VILLAGE OF BARRINGTON HILLS

Board of Health NOTICE OF MEETING

Re: Septic Review- 66 Brinker Road
Review #3

Re: Septic System Replacement - 39 Brinker Road
Review #1

SITE PLAN & SEPTIC SYSTEM DESIGN

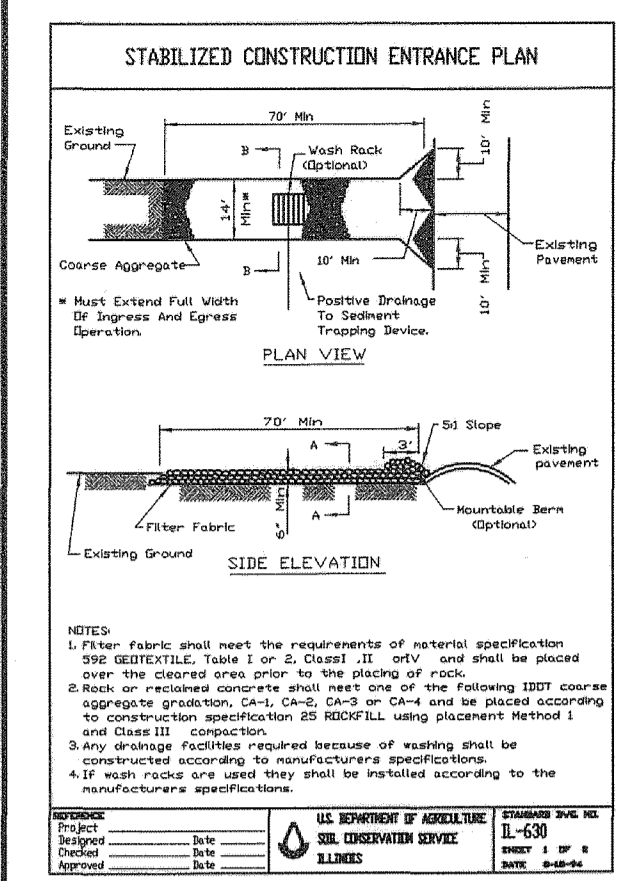
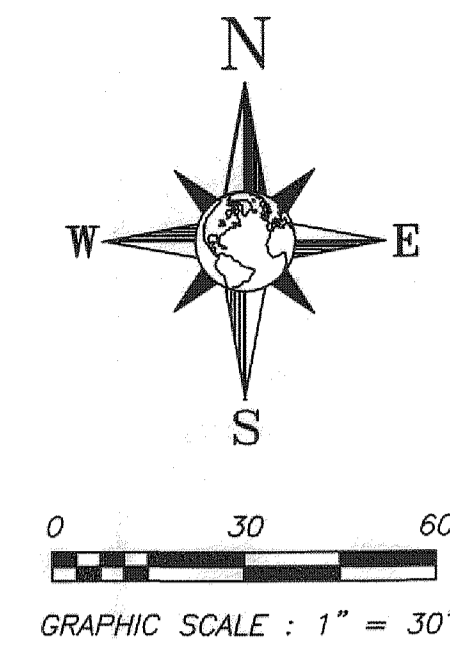
1. A Type V (mound) system has been proposed in order to meet the required 24" separation from the limiting layer, found to be at a 14" depth within the proposed septic area. Based on the Village Code a variance from the Board of Health would be required to allow a mound system. The next two regular Board of Health meetings are scheduled for Tuesday, July 15th and Tuesday, August 12th. The applicant should contact the Village Clerk to request that this item be placed on an upcoming agenda.
It is understood that this item will be on the Board of Health agenda for Tuesday, July 15th.

3. Provide a handrail and/or suitable barrier for the portions of the retaining wall that exceed 3' in height (adjacent to the proposed residence). In addition, if not already submitted with the architectural plan submittal a structural engineering plan signed and sealed by a structural engineer shall be provided for portions of the wall exceeding 3' in height.

Comment not addressed.

SEPTIC SYSTEM DESIGN
 39 BRINKER ROAD
 BARRINGTON HILLS, IL
 CLIENT: FRED HOFFMAN
 LEGAL: PART SECTION 3 TOWNSHIP 42N RANGE 9E
 SCALE: HORIZONTAL SCALE
 PIN: 01-03-301-042

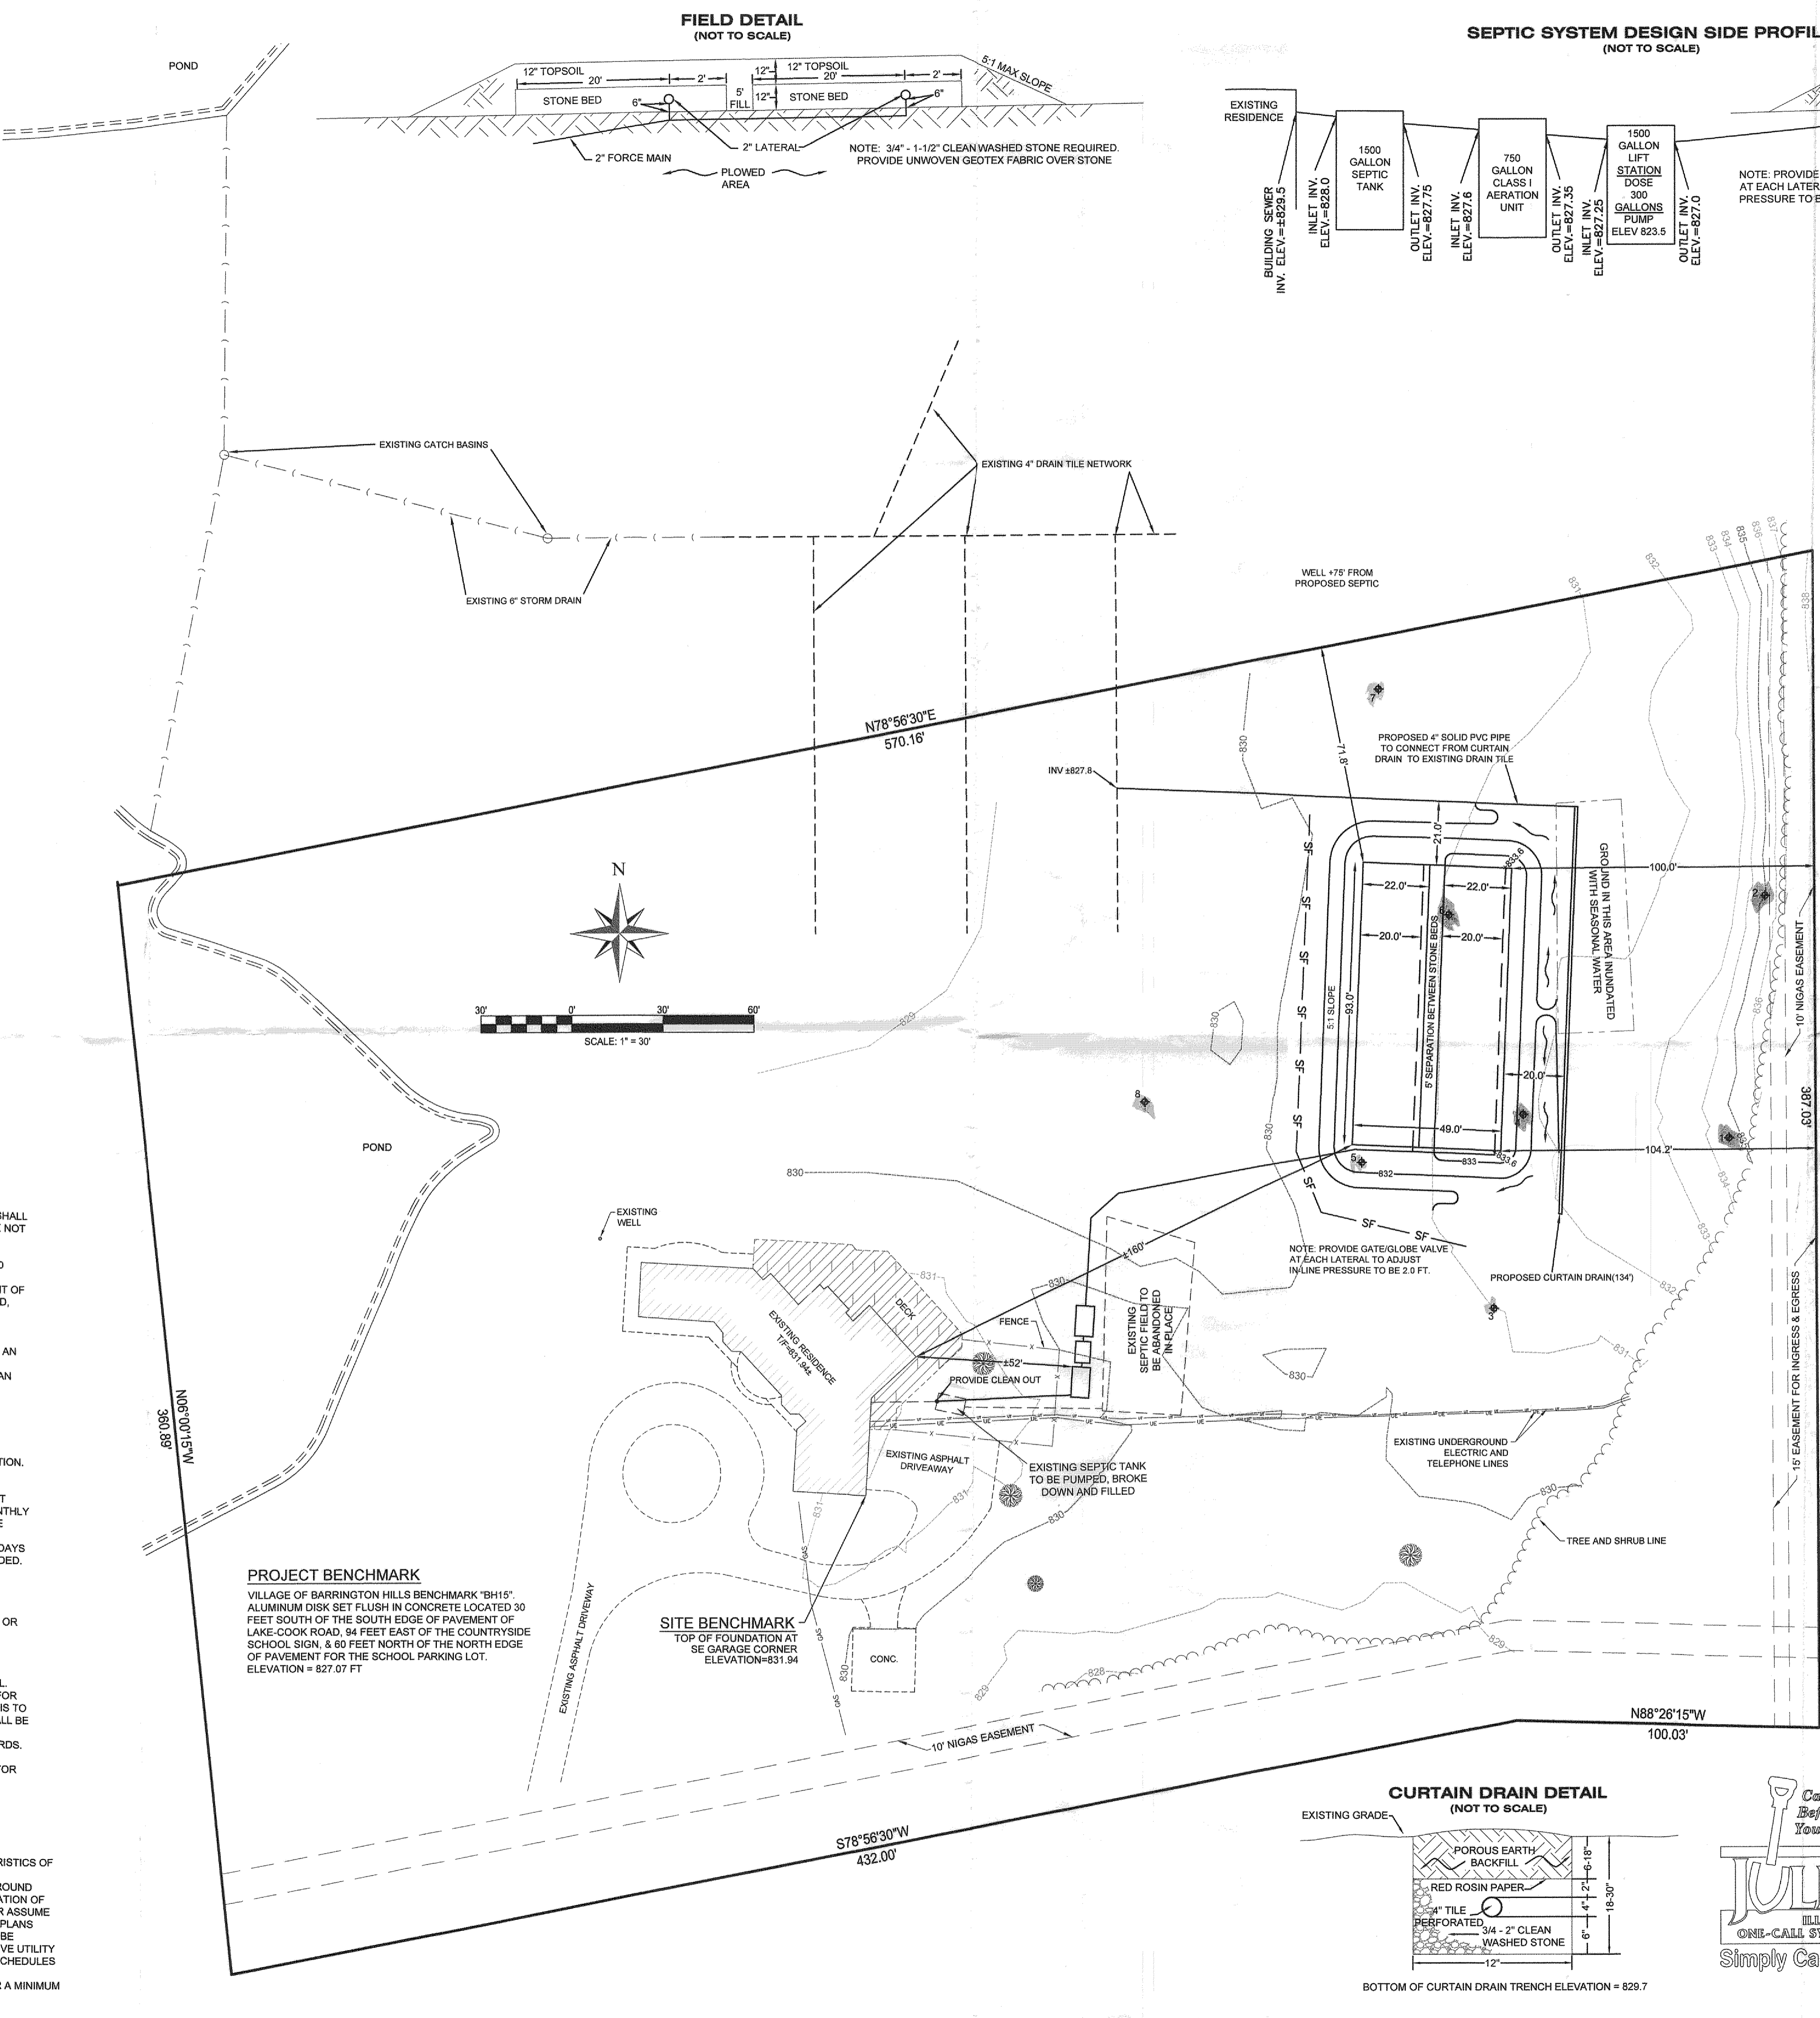
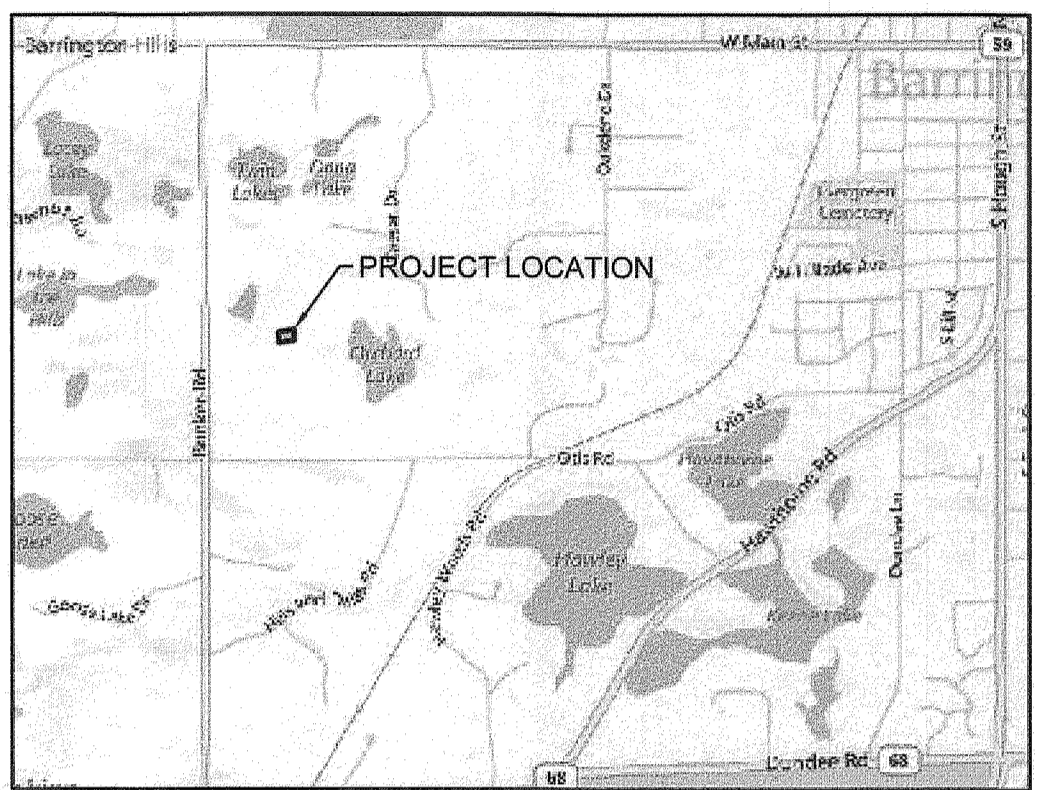
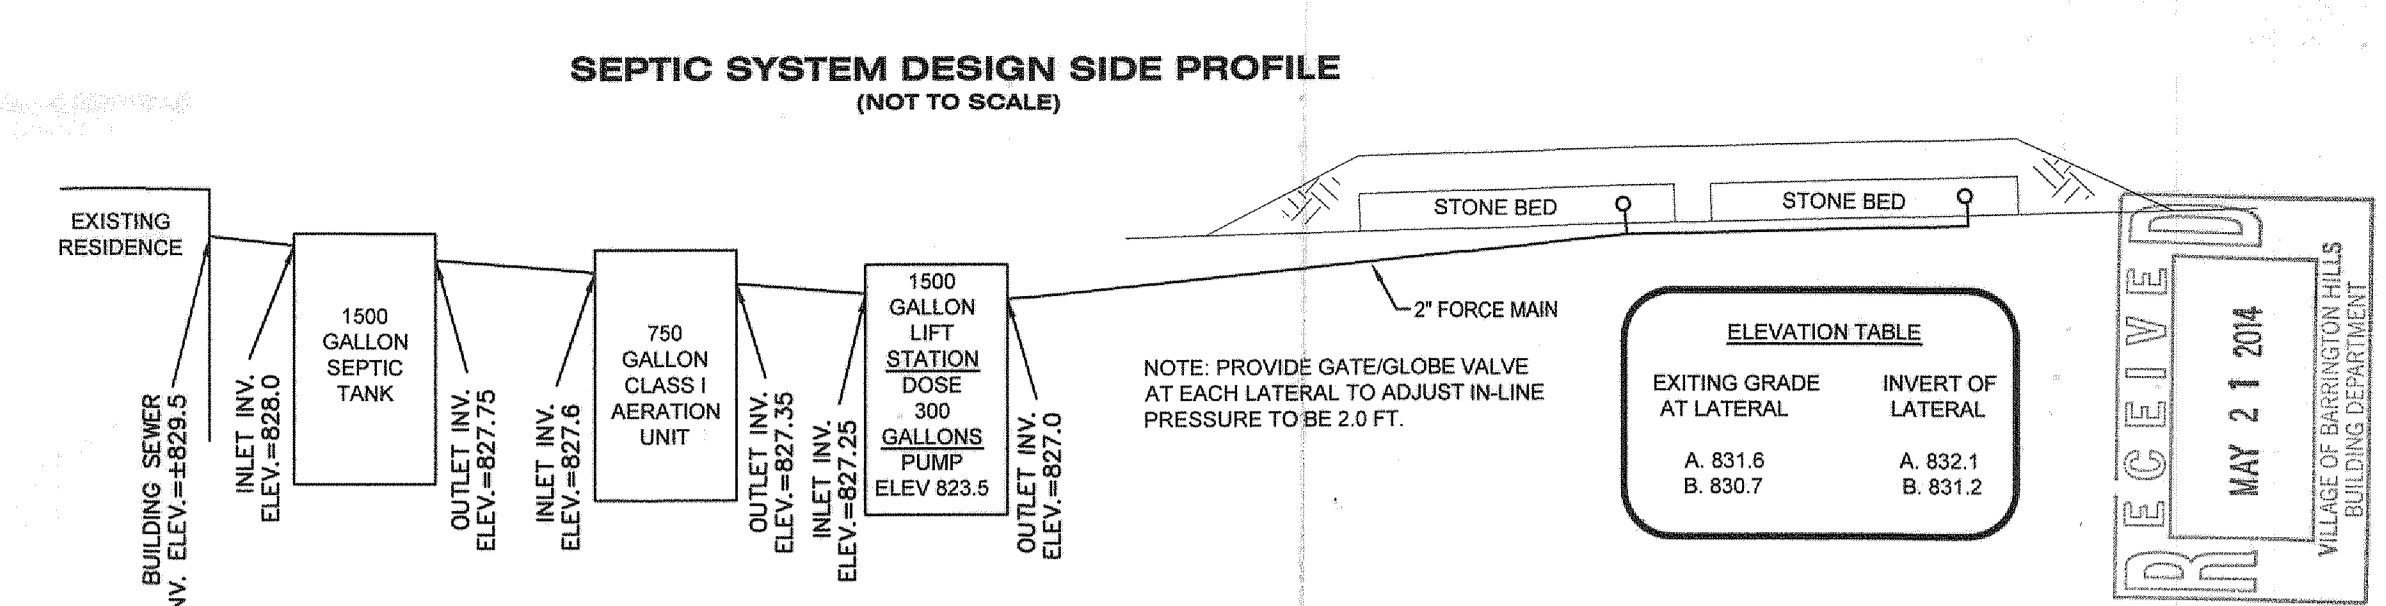
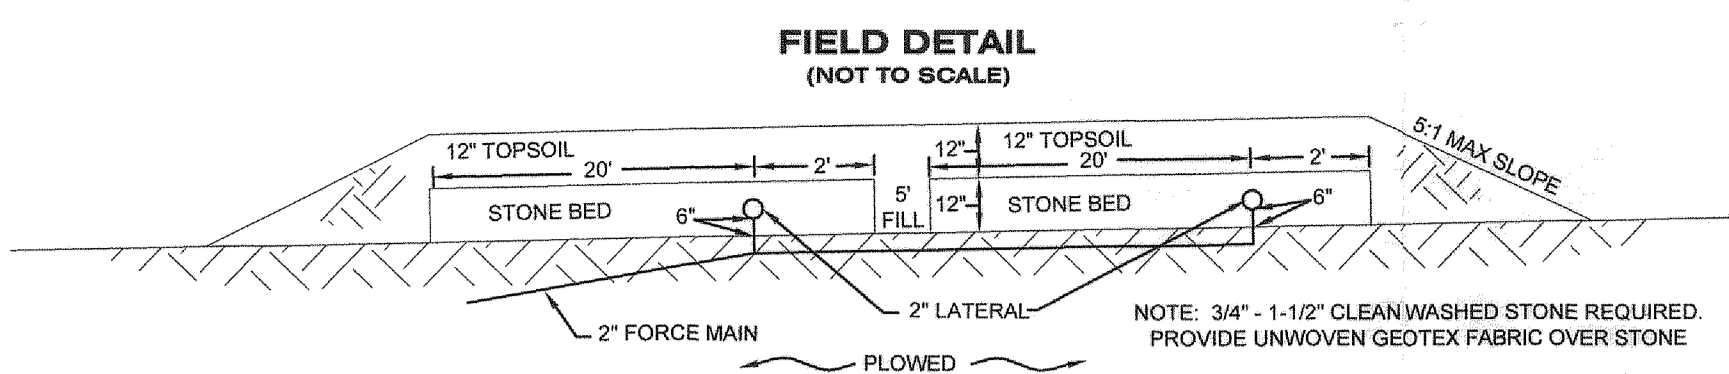
1. A Type IV (at-grade) system has been proposed in order to meet the required 24" separation from the limiting layer, found to be at a 17" depth within the proposed septic area. **Based on the Village Code a variance from the Board of Health would be required to allow the proposed at-grade system.** The next two regular Board of Health meetings are scheduled for Tuesday, July 15th and Tuesday, August 12th. The applicant should contact the Village Clerk to request that this item be placed on an upcoming agenda.

2. An "unofficial" soils report was received prior to application of the permit, but the final soils report has not been received. Provide a copy of this information for review.

3. Indicate invert elevations and slopes for the proposed curtain drain system.
4. It is recommended that the septic system shift to the northeast to take advantage of the minimal suitable soils that remain on the site.

5. It appears that the design calculations are based on the methodology developed by the Lake County Health Department for at-grade systems. This methodology is acceptable pending

approval of a variance by the Board of Health, but if this is the case, it is recommended that a LCHD worksheet be provided for the system to demonstrate compliance with this criteria.
